From: Ken Shimko <kshimko.meridianenv@gmail.com>
Sent: Monday, August 12, 2019 4:39 PM
To: Stoltz, Carrie R - DNR
Subject: Ladysmith Change Order - Install downgradient well nest, install/pump extraction wells to remove diesel LNAPL
Attachments: Change Order - revision 8-11-19.pdf

Subject: **Change Order:**

Autostop (former)
119 W. 9th Street North
Ladysmith, Wisconsin 54848
BRRTS No. 03-55-282548
PECFA No. 54848-1295-19
Meridian No. 05F630

Doug's Tire (former)
811 Lake Ave W.
Ladysmith, Wisconsin 54848
BRRTS No. 03-55-000408
PECFA No. 54848-1215-11
Meridian No. 05F786

Figure
Site Map

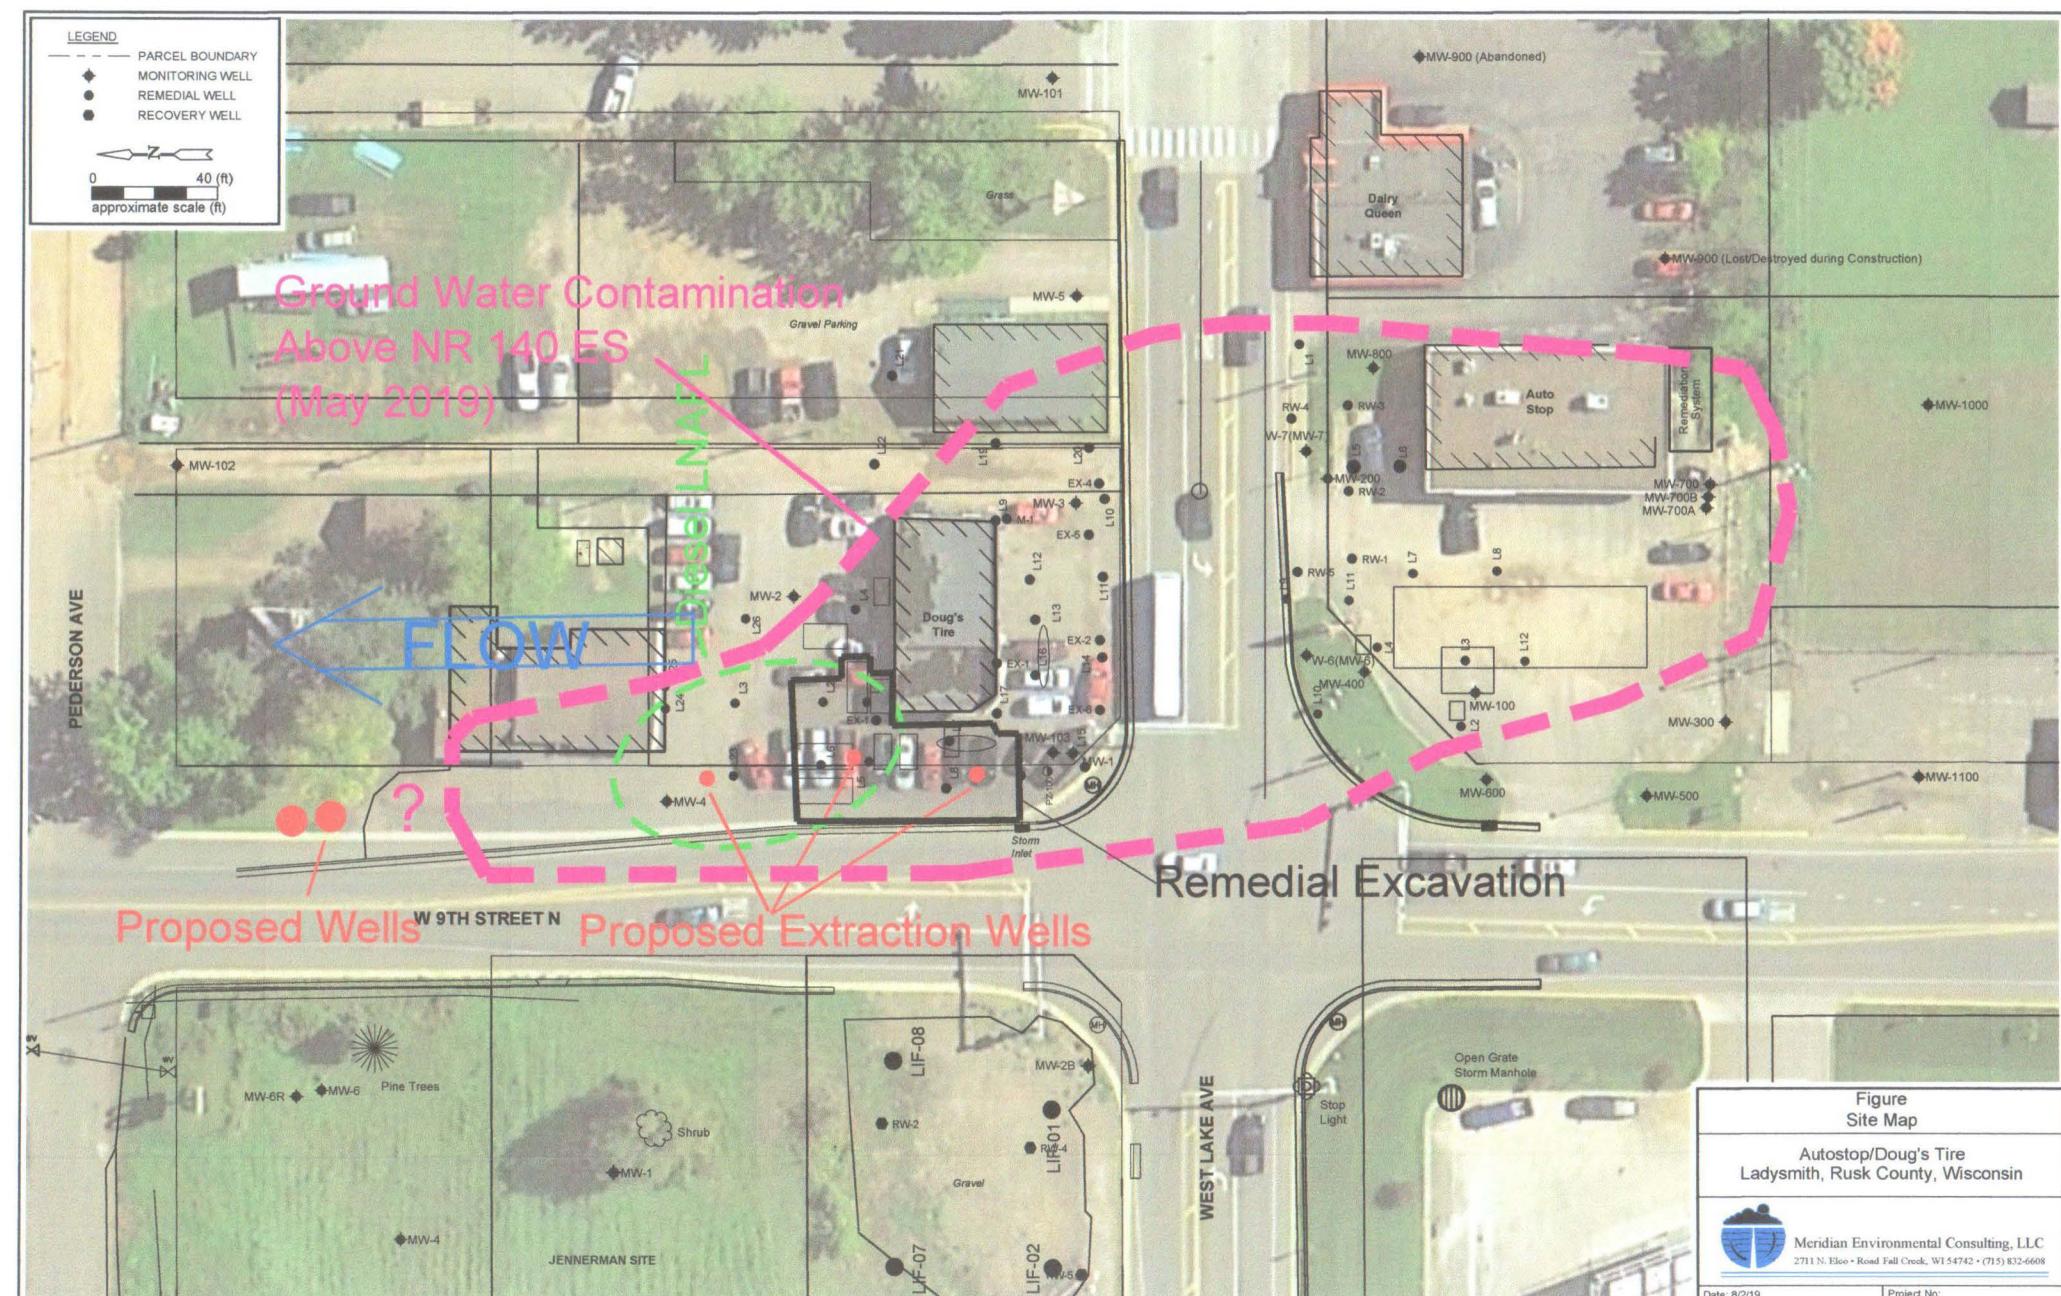
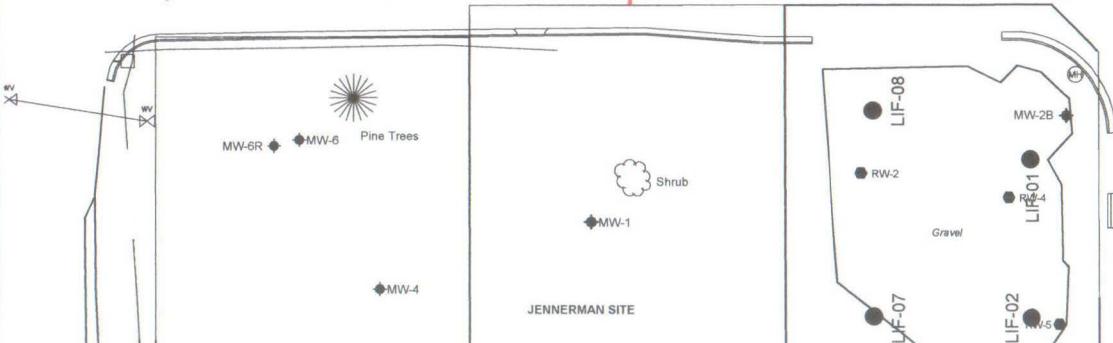
The extent of ground water contamination is not defined to the north. We recommend installing a well nest north of MW- 4 in the location shown on Figure 1. The water table well would be screened from 15 – 30 feet and the adjacent piezometer from 35 - 40 feet.

Diesel LNAPL was recently measured in MW-4. The LIF survey completed in 2012 identified diesel impacts at the smear zone in the northwest corner of the Doug's Tire property. The DNR recommended a remedial excavation as shown in Figure 1. The excavation was limited by the onsite building and Hwy. 27 (structural impediments).

We recommend installing three extraction wells (4 inch diameter) in the former remedial excavation (see Figure). The remedial excavation was backfilled with sand and diesel LNAPL may have accumulated in the coarse backfill material. The wells would be screened from 15 – 30 feet below grade and completed flush-grade. These extraction wells would be pumped weekly for 6 weeks using a vac truck. Monitoring wells MW- 4 and MW-103 would also be pumped during these weekly events.
